Public Service of New Hampshire
NEW HAMPSHIRE YANKEE DIVISION

Subject: Response to Information Requests Regarding New Hampshire Yankee
Division Implementation

Responses to Questions/Comments Regarding
New Hampshire Yankee Division Implementation

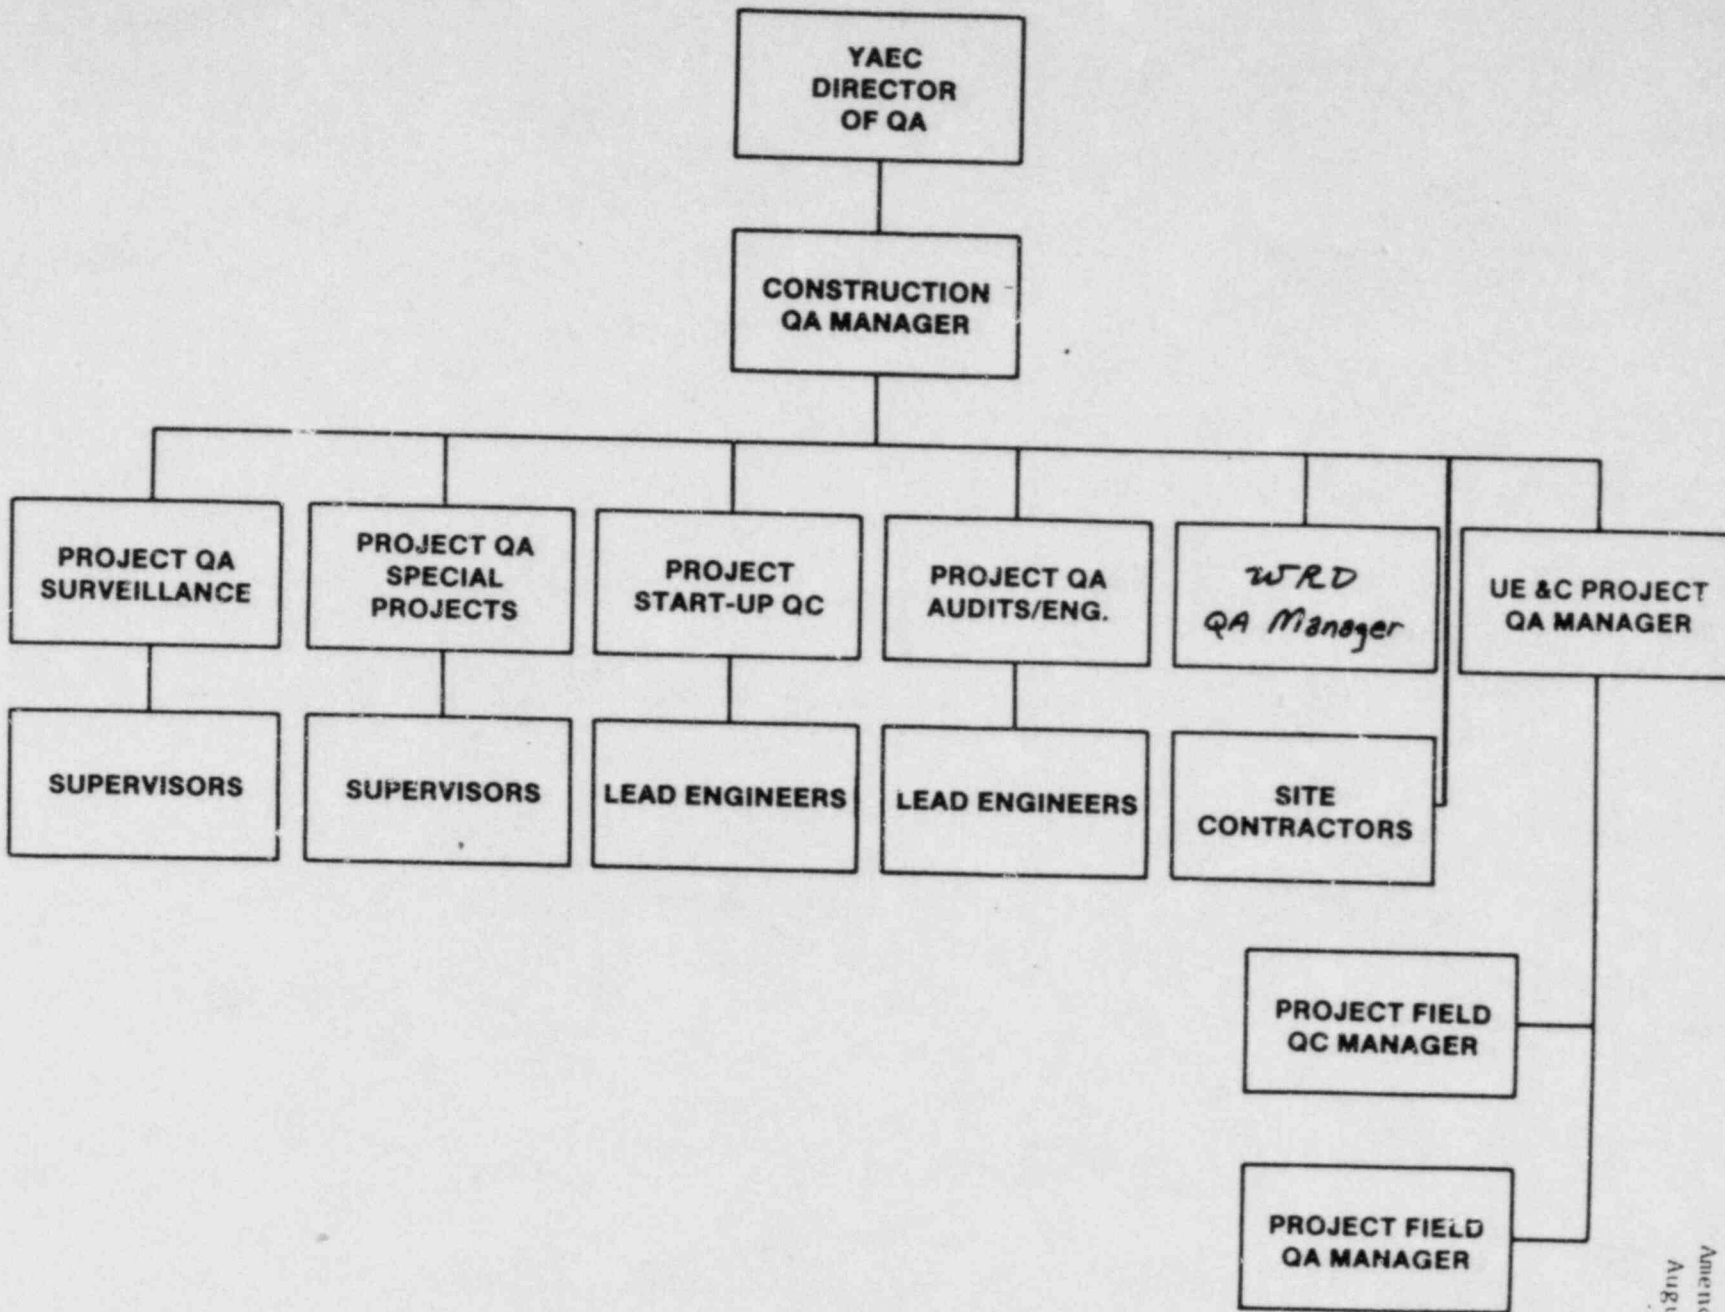
1. Describe in more detail the interface responsibility between the Quality Assurance organization of Yankee Atomic Electric Company (YAEC) Construction Department and the organizational units within the following: 1) New Hampshire Yankee Division (NHVD), 2) United Engineers and Constructors (UE&C), and 3) Westinghouse Electric Corporation (WRD).

FSAR Figure 17.1-1 (attached) has been annotated to fully identify the integrated Quality Assurance organization which is under the authority of the YAEC Director of QA and the YAEC QA Manager. A new Figure 17.1-1A (attached) has been developed to provide a composite illustration of the Quality Assurance interfaces existing on the Project. Also, FSAR Pages 17.1-6 (attached) and 17.1-8 (attached) have been annotated to provide a discussion of the Quality Assurance interface.

Interface between YAEC, UE&C and WRD is depicted in Figure 17.1-1 as is the line of authority over the contractors to assure necessary coordination and control of the Quality Assurance Program.
